S4.55 MODIFICATION

S4.55 MODIFICATIONS	
Change ID	Name
Ch-01	Courtyard wall moved into courtyard
Ch-02	Alfresco deck reshaped
Ch-03	New window to first floor bathroom (W29)
Ch-04	Western wall on first floor moved forward by 650mm & balcony removed
Ch-05	New window to ground floor Dining (W20)
Ch-06	W04 - Kitchen window size change
Ch-07	Skylights relocated from stairwell to hallway
Ch-08	Eastern balcony screen reduced in length
Ch-09	Cellar footprint revised to include sauna

S4.55 MODIFICATION	
project	1130 PITTWATER RD
COLLARROY	
drawing	COVER SHEET
drawn SM / PC	checked MA
date 09.02.24	scale @ A3
project no 2_23_10	drawing no D0000
	issue D

S4.55 MODIFICATION		
project	1130 PITTWATER RD	
drawing	COLLARROY	
drawn	SM / PC	checked MA
date	09.02.24	scale @ A3
project no	2_23_10	drawing no D2102
issue		D

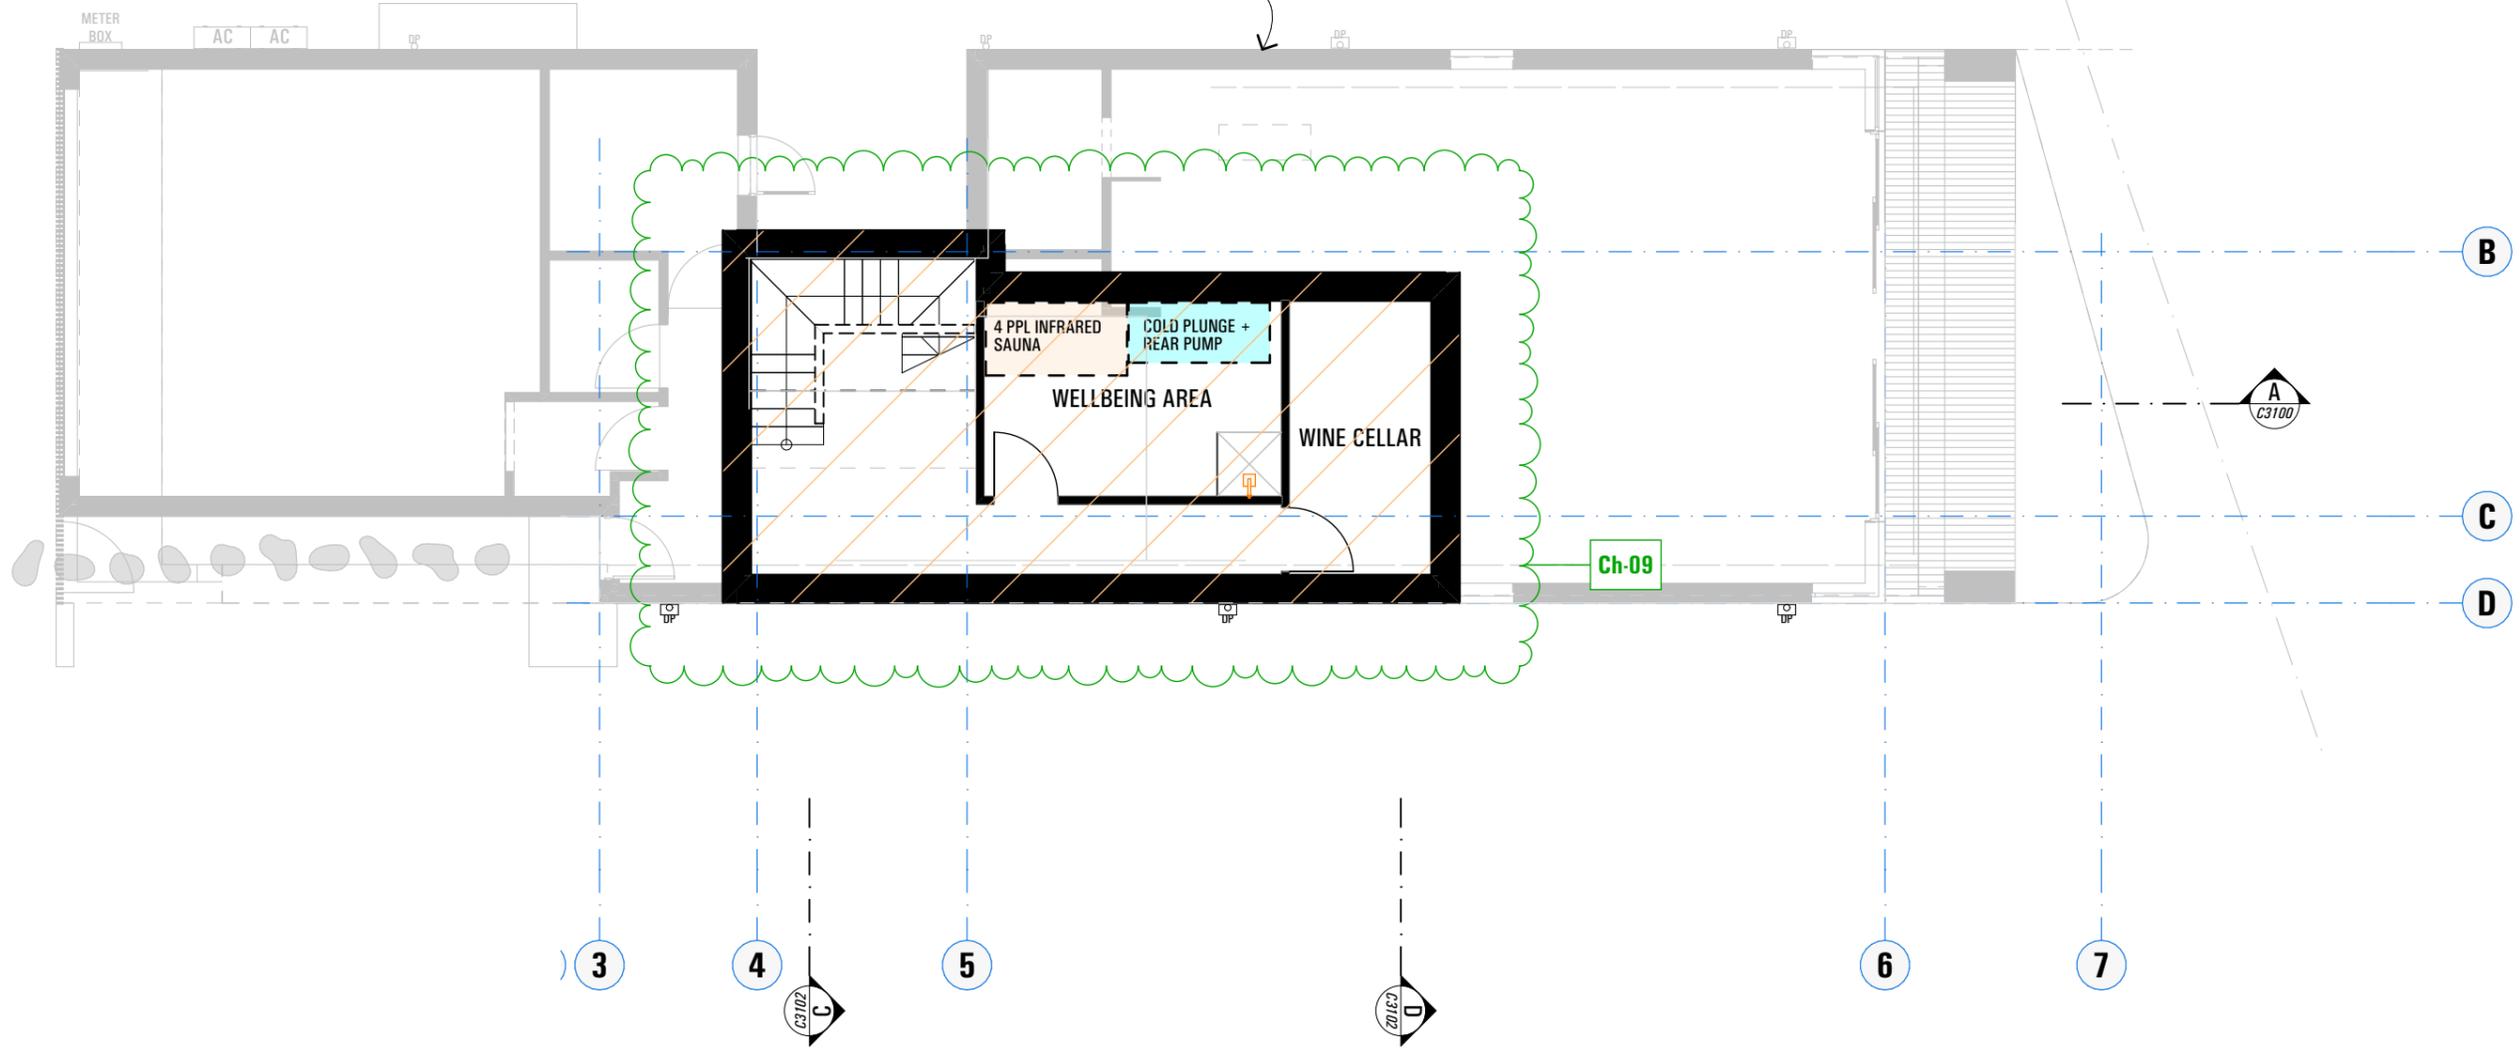
S4.55 MODIFICATIONS	
Change ID	Name
Ch-01	Courtyard wall moved into courtyard
Ch-02	Alfresco deck reshaped
Ch-03	New window to first floor bathroom (W29)
Ch-04	Western wall on first floor moved forward by 650mm & balcony removed
Ch-05	New window to ground floor Dining (W20)
Ch-06	W04 - Kitchen window size change
Ch-07	Skylights relocated from stairwell to hallway
Ch-08	Eastern balcony screen reduced in length
Ch-09	Cellar footprint revised to include sauna

S4.55 MODIFICATION		
project	1130 PITTWATER RD	
	COLLARROY	
drawing		
drawn	SM / PC	checked MA
date	09.02.24	scale 1:100 @ A3
project no	2_23_10	drawing no D3000
		issue D

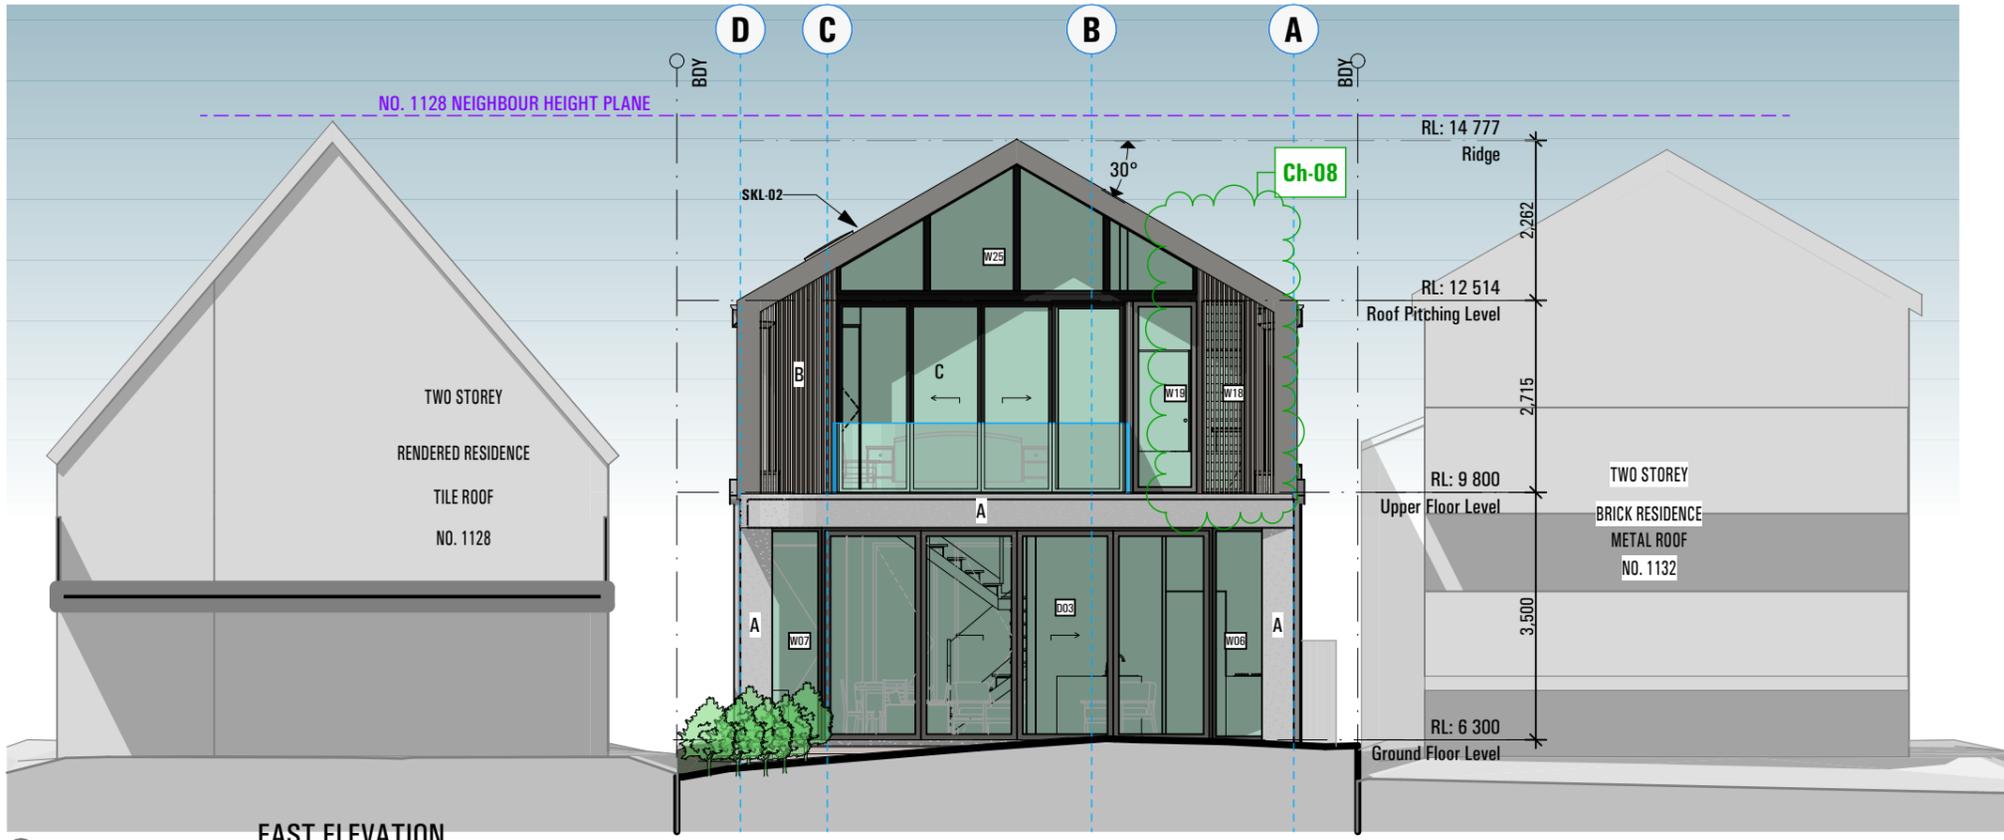
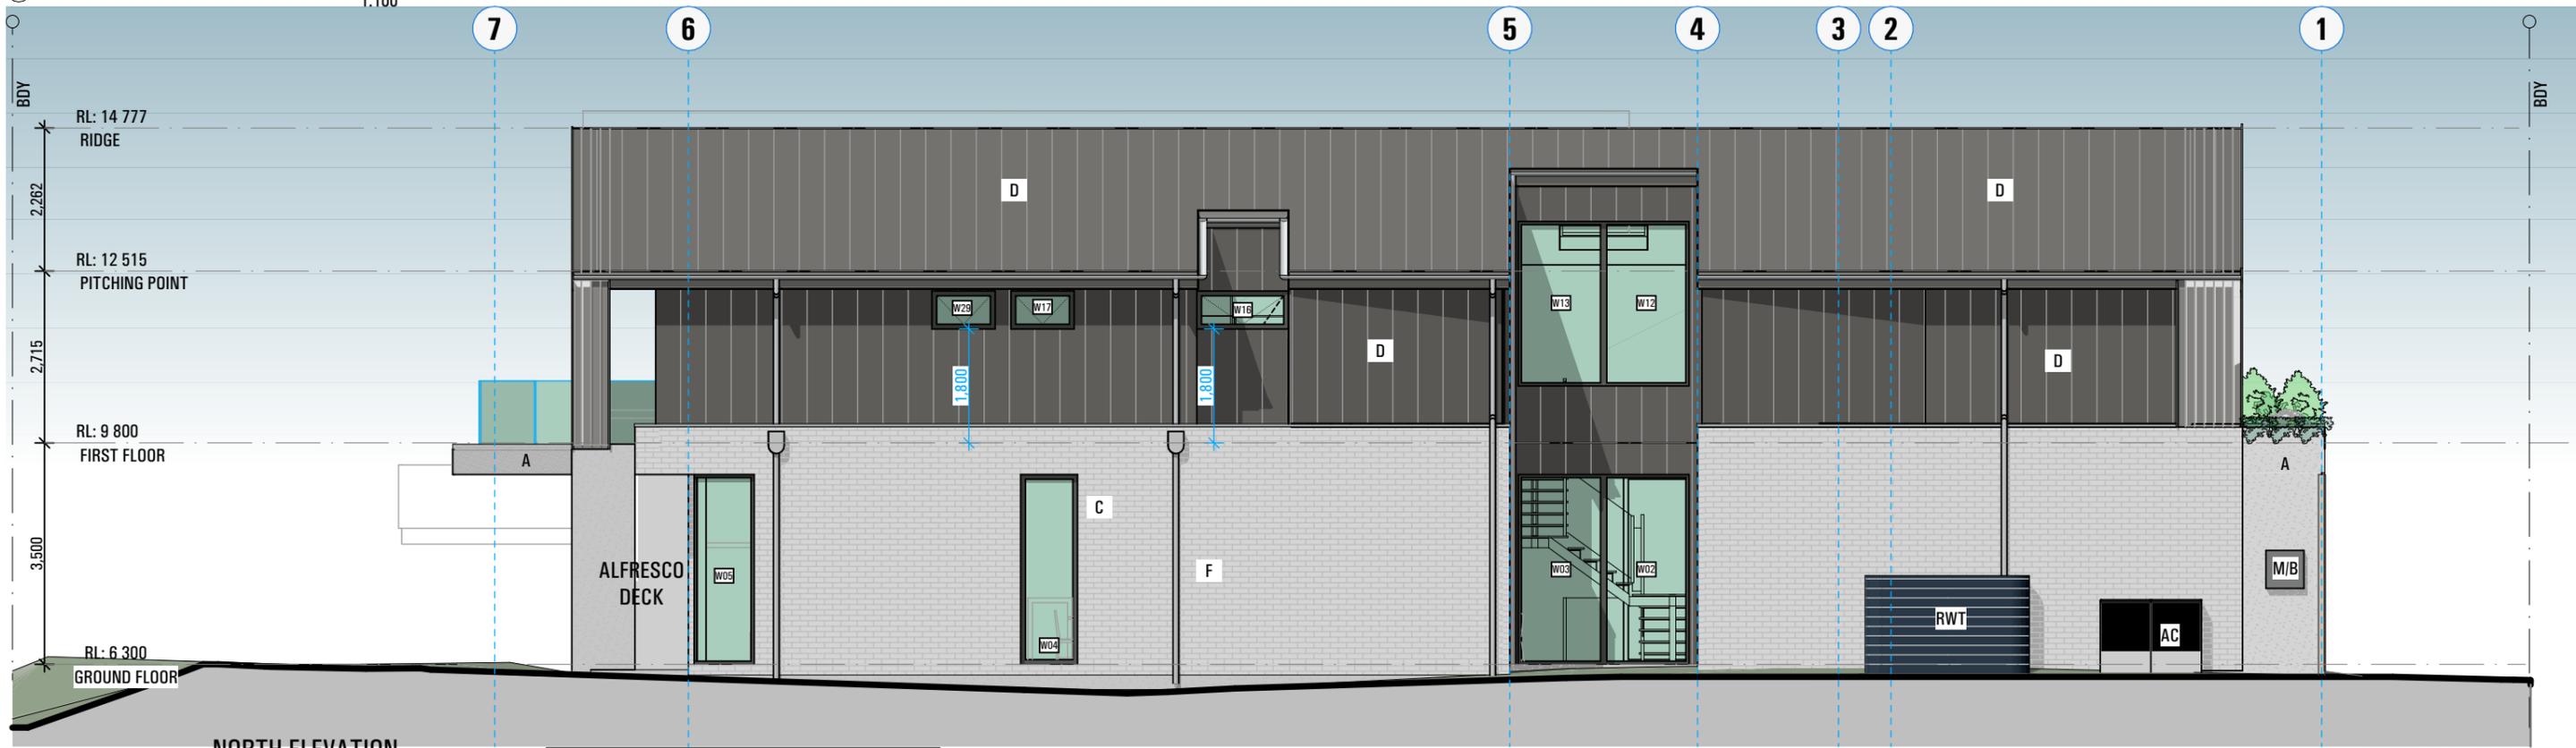
S4.55 MODIFICATIONS	
Change ID	Name
Ch-01	Courtyard wall moved into courtyard
Ch-02	Alfresco deck reshaped
Ch-03	New window to first floor bathroom (W29)
Ch-04	Western wall on first floor moved forward by 650mm & balcony removed
Ch-05	New window to ground floor Dining (W20)
Ch-06	W04 - Kitchen window size change
Ch-07	Skylights relocated from stairwell to hallway
Ch-08	Eastern balcony screen reduced in length
Ch-09	Cellar footprint revised to include sauna

drawing SOUTH/WEST ELEVATION
 drawn SM / PC checked MA

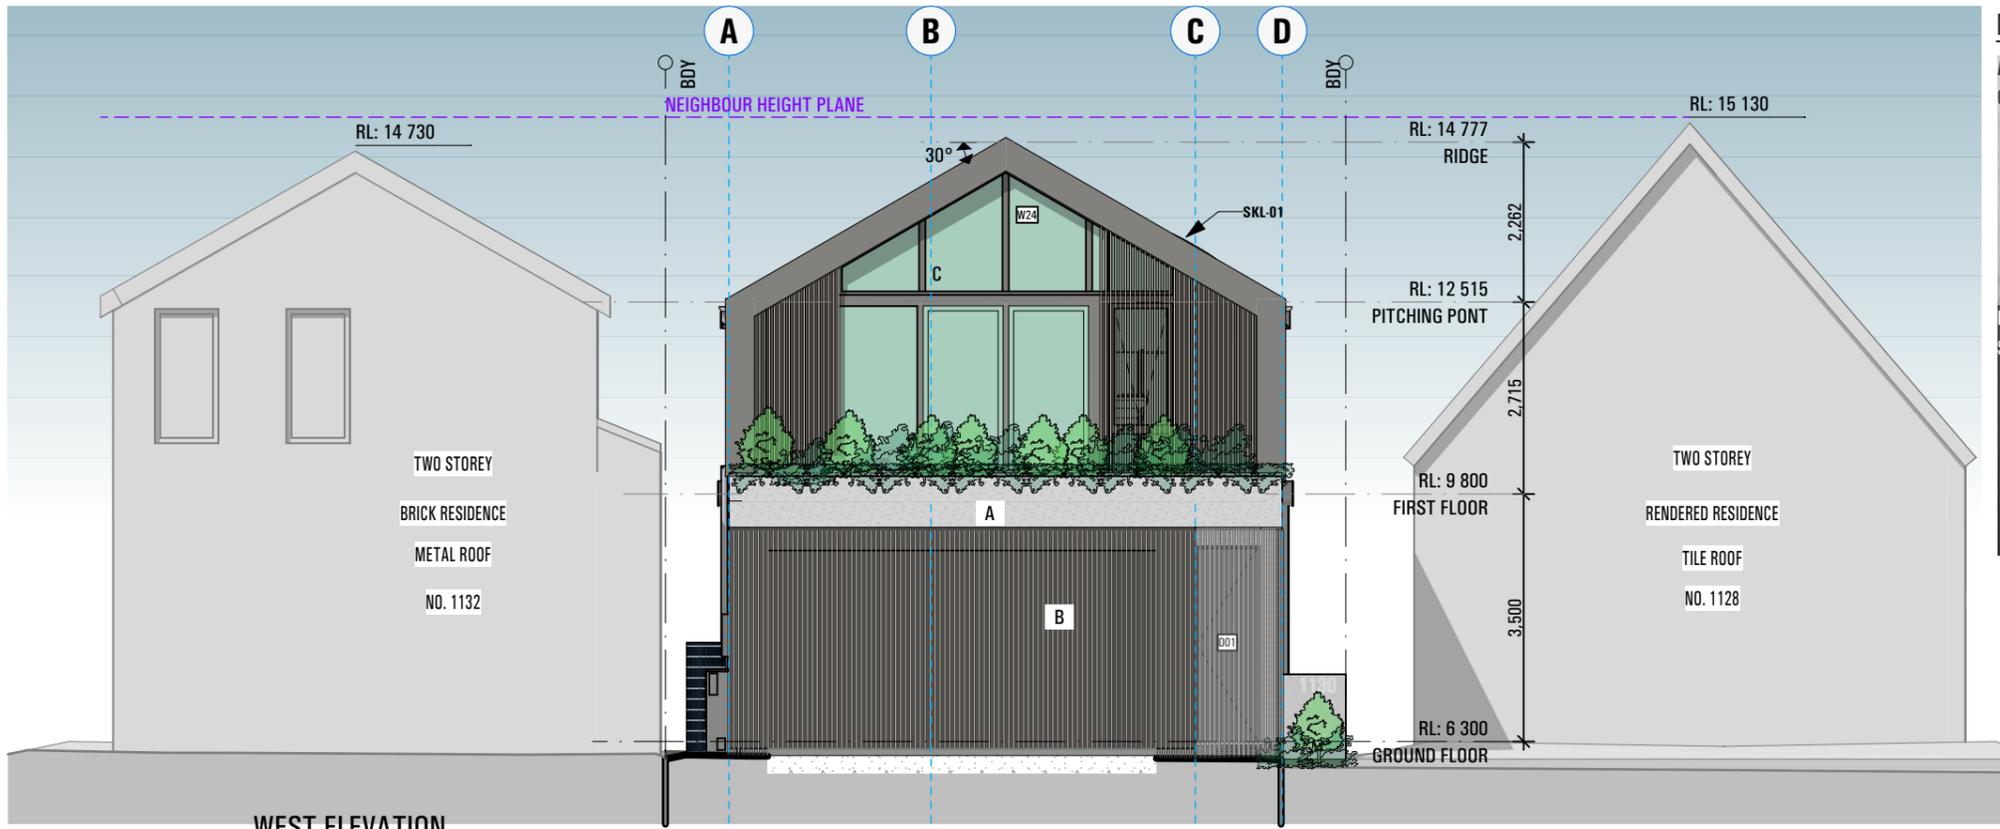
Change ID	Name
Ch-01	Courtyard wall moved into courtyard
Ch-02	Alfresco deck reshaped
Ch-03	New window to first floor bathroom (W29)
Ch-04	Western wall on first floor moved forward by 650mm & balcony removed
Ch-05	New window to ground floor Dining (W20)
Ch-06	W04 - Kitchen window size change
Ch-07	Skylights relocated from stairwell to hallway
Ch-08	Eastern balcony screen reduced in length
Ch-09	Cellar footprint revised to include sauna
